**CALIFORNIA GEOLOGICAL SURVEY
FAULT EVALUATION REPORT FER 253
SUPPLEMENT NO. 1**

**THE HOLLYWOOD FAULT
in the Hollywood 7.5' Quadrangle
Los Angeles County, California**

The purpose of this supplement to the FER is to review and address these public comments forwarded by the SMGB, comment on additional reports sent to CGS after preparation of the FER, and to comment on field observations of fault trenches and other subsurface investigations by CGS after the public comment period. The location of the study area is indicated on Figure 1 and the reader is referred to FER 253 dated February 14, 2014 for other necessary background material (<ftp://206.170.189.144/pub/dmg/pubs/fer/253>).

PUBLIC COMMENTS, AND RESPONSE

Figure 3 – Study site locality S1-1 indicated in blue shaded area. Boring transect shown as dark blue patterned line. Previous study sites included in the initial FER shown in light green.

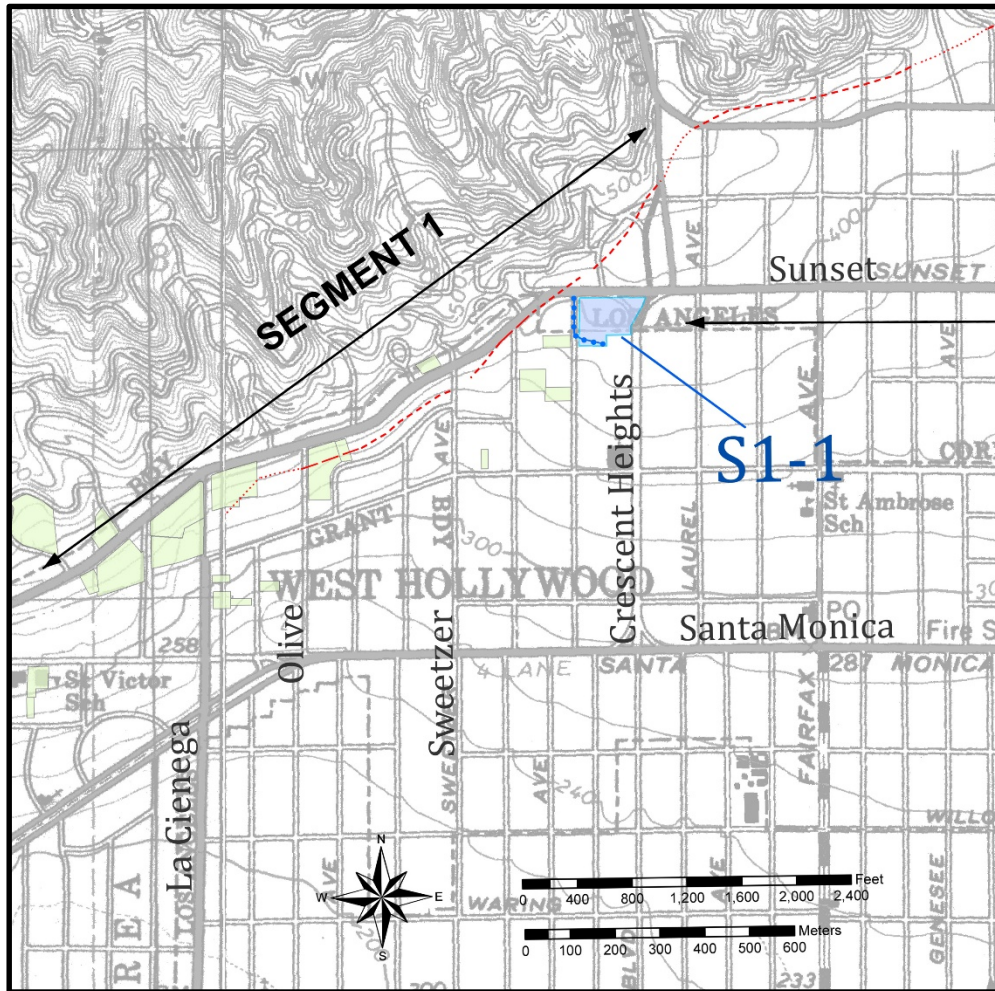
Golder Associates, Inc. (2014a, b) prepared a Surface Fault Rupture Hazard Assessment and Geotechnical Exploration study for a residential and commercial development located on the southwest corner of Sunset Boulevard and Crescent Heights (locality S1-1) as shown on Figure 3. Golder's site evaluation included a CPT transect and hollow stem auger boreholes along the western and southern site boundaries. They interpreted this transect to show continuous alluvial stratigraphy across the site. They reported silts and gravelly sands deposited less than 7 thousand years ago (ka) to depths of about 40 feet. Lower deposits ranged in age from 9 ka to 13 ka at depths of about 60 to 80 feet. They concluded the site has not had major disruption from Holocene faulting.

The data presented by Golder Associates are consistent with the interpretation presented in the initial FER that the Hollywood Fault lies north of this site as shown on the preliminary Alquist-Priolo Earthquake Fault Zone map.

Figure 4 – Index map showing new localities S2-1 and S2-2. Trench locations indicated as orange line segments. Previous studies included in original FER shaded green.

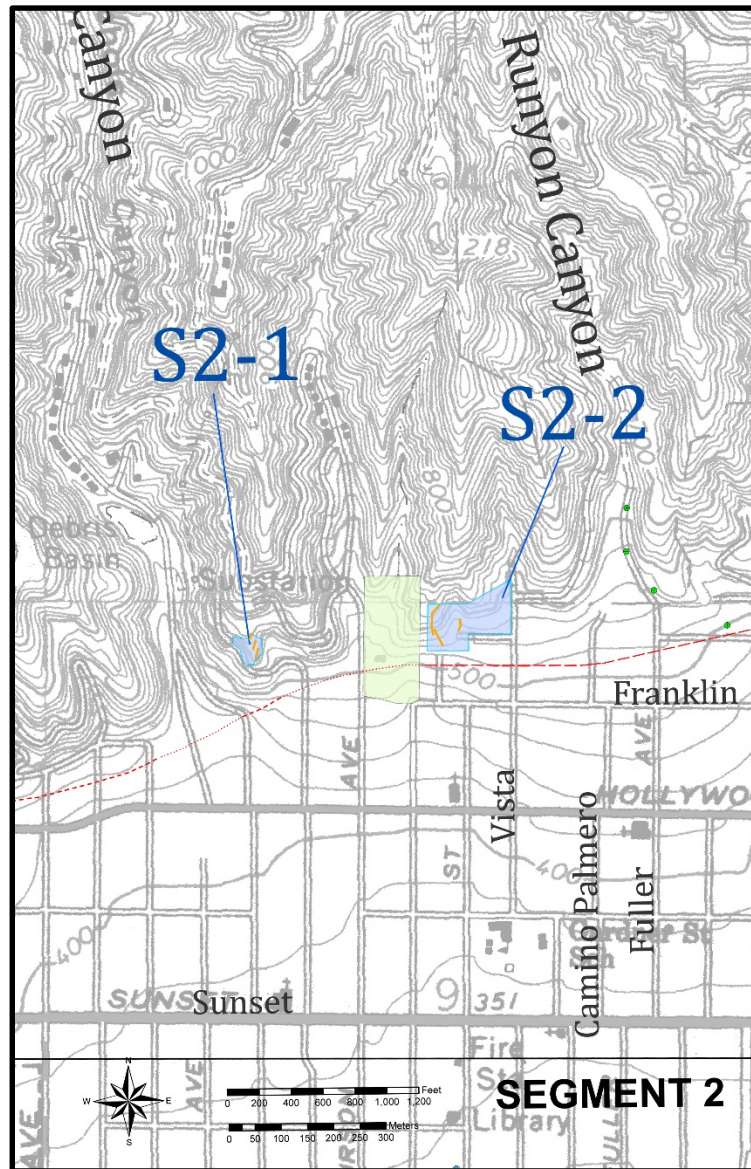
Irvine Geotechnical, Inc. (2014) performed a fault investigation for a residential project located near the base of the Santa Monica Mountains at locality S2-1 (Figure 4). Geologic mapping and shallow trenches were performed as part their study. A geologist for the City of Los Angeles observed the excavation during the study, where un-faulted quartz diorite bedrock was exposed.

Grover Hollingsworth and Associates, Inc. (2014) conducted a fault investigation for a project located along the southern edge of the Santa Monica Mountains, near Runyon Canyon at locality S2-2 (Figure 4). They excavated three fault trenches across the site and observed a thin layer of soil overlying quartz diorite bedrock. Caliche-lined faults were observed in Trenches 1 and 3, but clay gouge and slickensides were not observed in the fault zone. With field review and discussion with the City of Los Angeles geologist, Grover Hollingsworth considered these faults to be pre-Holocene.

The data presented by Irvine Geotechnical and Grover Hollingsworth and Associates for localities S2-1 and S2-2, respectively, is consistent with the interpretation that no Holocene faults cross these sites north of the fault shown on the preliminary Alquist-Priolo Earthquake Fault Zone map.

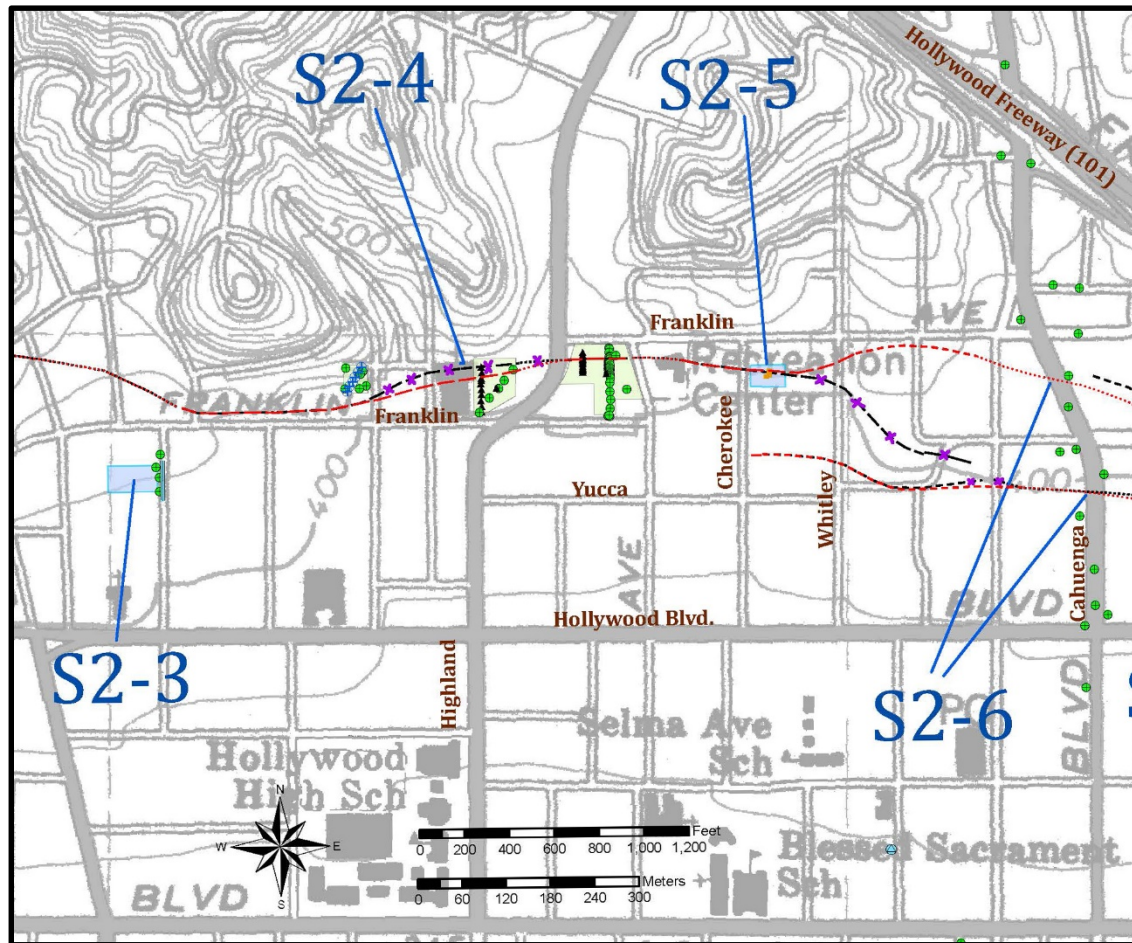
At locality S2-4 (Figure 5), (locality 12 in Hernandez and Treiman, 2014), CGS re-evaluated the fault strands at this site and compared them to the well-defined and well-constrained fault data immediately east of this location (Hernandez and Treiman, 2014), locality 13), as well as new data to the east at locality S2-5 (described below). There were several fault strands indicated in investigations at this site, and the re-assessment of the data led us to select a different strand as the dominant trace.

CGS made observations of two fault trenches at locality S2-5, south of Franklin Avenue and N. Cherokee Avenue (Figure 5). Two separate visits were made to this site by J. Treiman (CGS). The southern trench, first visited on December 31, 2013, exposed southeast dipping Topanga Formation siltstone and sandstone, with interbedded or injected volcanics. No faults were observed in this trench at this time. A northern trench, visited on January 15, 2014, revealed a broad fault zone (about 20 to 30-feet wide) within the Topanga Formation. Bedrock to the north and south of the fault zone dipped moderately to the northeast. Within the fault zone, bedding and shears had an east-west strike with steeply north to vertical dips. Shearing increased toward the northern margin of the zone which had a sharp vertical shear and a soil-filled fissure. The north margin of this soil-filled fissure appeared planar, indicating the soil was faulted, rather than just falling into a shaking-related fracture. A visit to a freshly cleaned exposure at the initial southern trench, also on January 15, showed a shallowly north-dipping shear within the bedrock to the graded surface. Soils overlying the bedrock in the northern trench appeared to be very young. To date no report has been submitted by the owner to the City of Los Angeles or CGS.

Based on our re-evaluation of these data, we suggest a modification of the fault trace slightly to the south to project through this preferred trace, connecting the well-located fault to the east with better defined scarps to the west.

Our observations confirm the location of the northern strand of the Hollywood fault as presented in the initial FER.

Figure 6 – Cross section from the Metro Red Line subway project. Portion of figure from Converse et al, 1984.

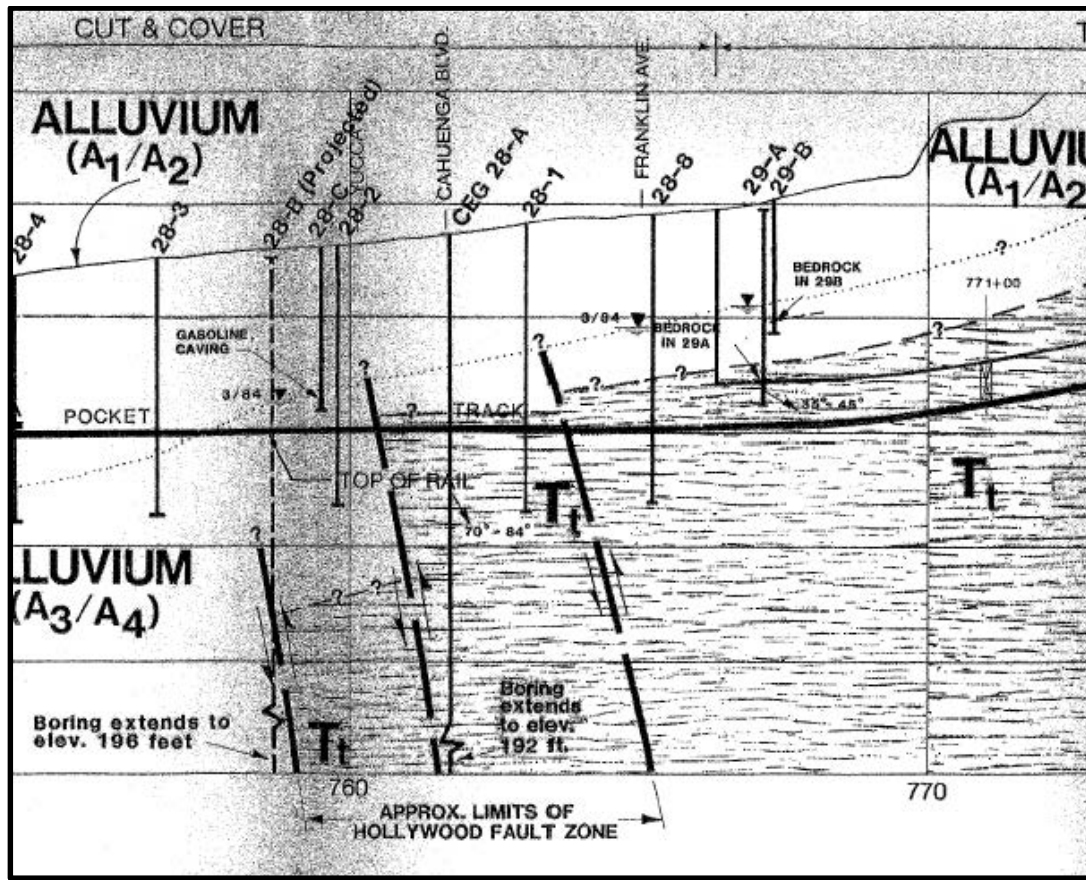
Converse Consultants, Earth Sciences Associates, Geo/Resource Consultants (1984) – locality S2-6 (Figures 5 & 7): CGS acquired a geotechnical report prepared by Converse Consultants et al (1984) for the Metro Rail Red Line Project that was not available for the initial FER (Hernandez and Treiman, 2014). The initial FER relied on data from Converse Consultants et al, (1981, 1983) and Crook and Proctor (1992), and, although the borehole data from the 1984 report were described by Crook and Proctor (1992), the original borehole logs were not in the 1981 and 1983 reports that they reference.

The data presented by Converse Consultants et al (1984), specifically a cross section (Figure 6 herein) and boring logs, combined with observations of the fault at locality S2-5, support an eastward continuation of the northern fault trace, rather than the southeast trending orientation shown in the initial FER (that was based on Dolan et al., 1997)(Figure 7). We find the stratigraphy within the MTA boreholes reveals lateral discontinuities within the upper alluvial soils above the principal fault strands, in addition to offset bedrock as illustrated in the cross-section (Figure 6). The Converse Consultants data also supports the location of the southern trace of the fault where it crosses Cahuenga Boulevard as shown on the preliminary Alquist-Priolo Earthquake Fault Zone map. Additionally, the cross section shows a third fault that projects toward

the ground surface at Yucca Street, roughly between the northern and southern strands (Figure 6). Due to uncertainty as to how the various strands of this complex fault zone connect to the east and west we are only depicting the northern and southern fault traces on the Official Zone map.

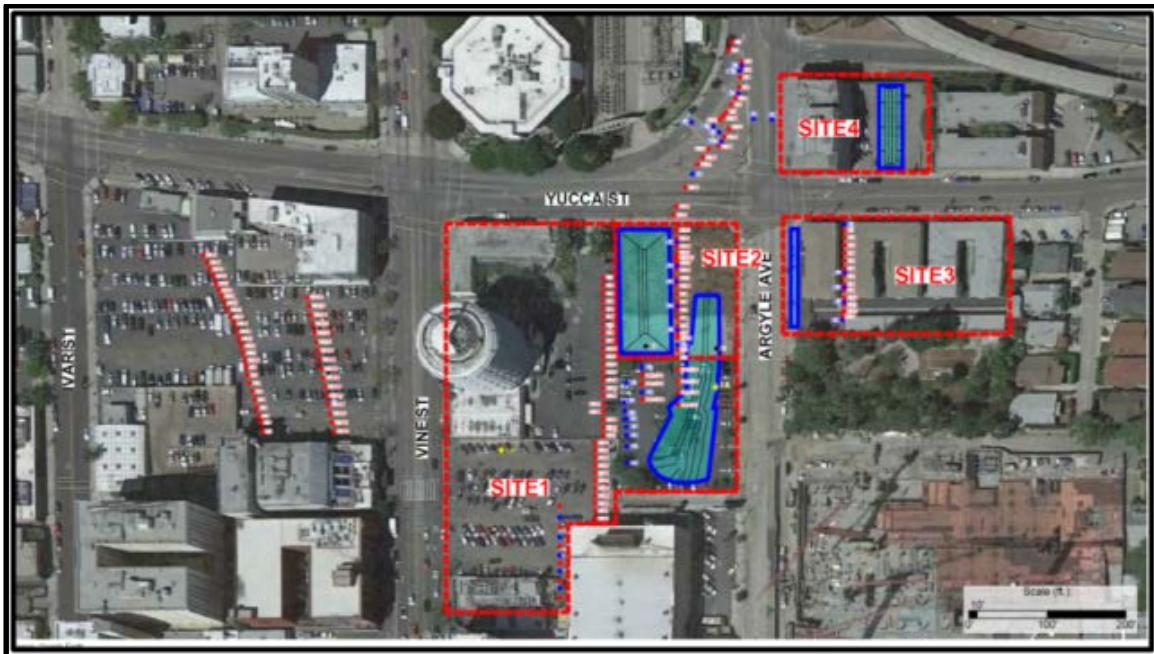
A comment was submitted by Mr. Michael Reader of Group Delta Consultants, Inc. (GDC) on March 13, 2014 to the SMGB for locality S2-8 (GDC Site 2, Figure 8). Mr. Reader stated that although there are mapped locations where the Hollywood Fault is somewhat well-defined, in the area between Cahuenga Boulevard and Gower Street the Hollywood Fault is concealed by alluvial fans, and that no data in this area have located the active trace. He also reported that the geologic community agrees the active trace of the Hollywood Fault lies “somewhere” in this area. However, he questioned the delineation of the zone for this area, with such sparse available data.

A fault study, conducted by Group Delta Consultants, Inc. (2014a) was submitted to the SMGB on May 6, 2014 for locality S2-8 (GDC Site 2, Figure 8). This study included core boring and CPT transects and an approximate 100-foot long, 30 foot deep trench on the western portion of the site. GDC reported that they found no evidence for faulting in the Holocene units on this site. The study also reported age estimates of weathered soil horizons at two locations within the trench, prepared by Dr. Roy Shlemon, and included test results from two charcoal samples submitted for C14 dating.

GDC reported the site is underlain by fluvial channel deposits, locally named the Argyle Channel, which they estimate to be Holocene. Underlying the Argyle Channel deposits, they report a clayey sand layer. The contact between the lower clayey sand and the overlying Argyle Channel sands is reported to be an erosional unconformity. The lower clayey sand is reported to be at least 12 to 15 ka, based on relative soil pedogenic development exposed in the trench. Age estimates by GDC are based on soil development described by Dr. Roy Shlemon, in Appendix B of their report, and correlation of the unconformity with ice age sea-level low stand at during marine isotope stage 2. Radiocarbon dates reported for the Argyle Channel deposits were about ~4.3 ka, and ~41 ka at about 14 feet, and 18 feet below the ground surface (bgs), respectively. GDC prefers the soil-stratigraphic and paleo-environmental age estimates for the Argyle Channel deposits and does not use the radiocarbon dates.

A second Fault Activity Report was submitted by GDC for locality S2-8, dated September 3, 2014 (Group Delta, 2014b). This investigation consisted of additional CPT and core borings from adjacent sites in the vicinity, and an additional trench located on the eastern portion of the site that also extended south into GDC Site 1 (locality S2-9). During this second investigation, GDC reported a bedding plane fault underlies the site, where they concluded this fault is overlain by a buried paleosol “indicative of about 30 ka of weathering.” This trench was excavated in response to comments by the City of Los Angeles noting that faulted Pleistocene sediments were found directly across the street to the east (GDC, Site 3; locality S2-11). Within this eastern trench at locality S2-8, Argyle Channel deposits were exposed, underlain by mudflow deposits (previously referred to by GDC as the clayey sand or “basal clay” unit). Underlying the mudflow deposits they reported well-consolidated older alluvial debris flow deposits that are dipping gently to steeply to the south. C14 dates near the base of the Argyle Channel deposits were reported at ~4.1 to 4.3 ka. (Group Delta, 2014a, 2014b). The soil ages within the trench were derived from soil profile descriptions from R. Shlemon. GDC concluded that folding and related slip observed in their trench occurred prior to deposition of the mudflows, capped by a remnant buried paleosol of about 30 ka, and are overlain by the unbroken, estimated ~12 ka Argyle Channel deposits.

The data presented in the GDC report appear to be consistent with the interpretation that the Argyle Channel deposits are of Holocene age. However, multiple C14 samples GDC reported within their trenches near the base of the Argyle Channel, are only ~4.3 ka and thus the channel deposits do not represent the complete Holocene record. We consider the Argyle Channel deposits to be approximately 6 ka, based on C14 data throughout the two trenches, and related soil development. The interpretation that the underlying clayey deposit is pre-Holocene appears to be consistent with the reported data. Detailed analysis of the soil profile development was prepared by G. Seitz, of CGS, and is included in Appendix A of this supplement. This analysis includes further comments regarding the reported age classification of the Argyle Channel deposits, and underlying clayey sand unit.

The data presented in the GDC report regarding faulting of these deposits is also open to alternate interpretations. The trench log and correlation by GDC show that Argyle Channel deposits are unfaulted across much of the site. CGS performed a field review of the west trench on two occasions, the first was not extensive enough to verify all of the consultant's conclusions due to safety concerns, however a subsequent visit afforded the opportunity to view the clayey sand deposits and relative soil development at the base of the trench. Our review of the CPT and core boring data for GDC Site 2 finds the Argyle Channel sand unit appears to be continuously correlated between borings and CPT tests, however the underlying clayey sand unit is shown to be discontinuous across portions of the site. Our review further notes the cross sections illustrated by GDC favor the CPT correlations, where core boring data in some areas does not directly support their stratigraphic interpretation.

Based on this new trench data, as well as other data, we have relocated the northern fault strand to project along Yucca Street toward the north. The southern fault strand is also modified in this area based on data from locality S2-9 (GDC Site 1), described below.

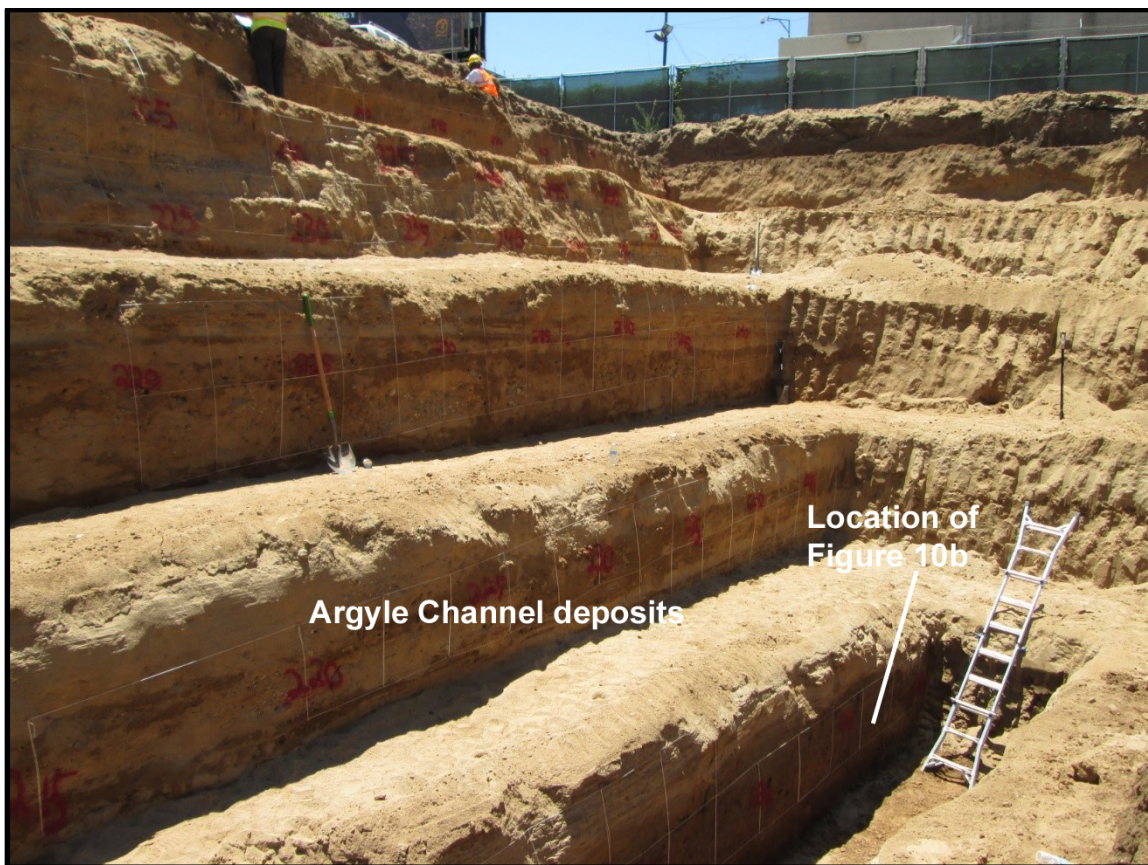
Group Delta Consultants, Inc., (2014d) prepared a limited data report from a Fault Activity Investigation for locality S2-9 (GDC Site 1, Figure 8). Their investigation included core borings, a CPT transect and an approximate 240 foot-long, 30 foot-deep trench on the eastern portion of the site (a southward extension of the trench to the north on site 2). The GDC letter report includes a summary of technical findings that includes a summary of the interpretations for other sites surrounding Site 1. The only data provided in the report are CPT logs and two interpreted CPT profiles. Trench logs, borehole logs and age dating results were not provided. GDC reported an unbroken late-Pleistocene mudflow deposit and overlying Holocene Argyle Channel deposits within Site 1.

CGS was invited to the site for periodic trench review between June 30, 2014 and July 11, 2014, where we observed unbroken Argyle Channel deposits overlying an older unbroken unit that was tentatively correlated by GDC staff to mudflow deposits observed to the north. In the northern portion of Site 1 near the boundary with Site 2, the late-Pleistocene mudflow unit appears to be draped over the underlying folded debris flow units, and what may be the same unit appears near-horizontal as it extends to the southern end of the trench (Figure 10a).

We received no logs of this part of the trench to clarify these relationships.

Figures 10a, 10b show the stratigraphy in the south end of the trench. Our review of the CPT data for this site, and some earlier core borings (from GDC Site2) indicates a discontinuous south-dipping Quaternary stratigraphic section, with a prominent stratigraphic break toward the southern end of the property indicative of a fault. The orientation of this break appears to be north-dipping, projects upward toward the ground surface near the southern property boundary (south of the trench exposure), is in alignment with the fault scarp located north of Carlos Avenue immediately to the east, and is in alignment with an inferred fault trace from the Langan data west of Vine Street (locality S2-7) to the west. On the basis of these observations, the southern trace of the Hollywood Fault has been moved to the southern boundary of locality S2-9, just south of the trench exposure.
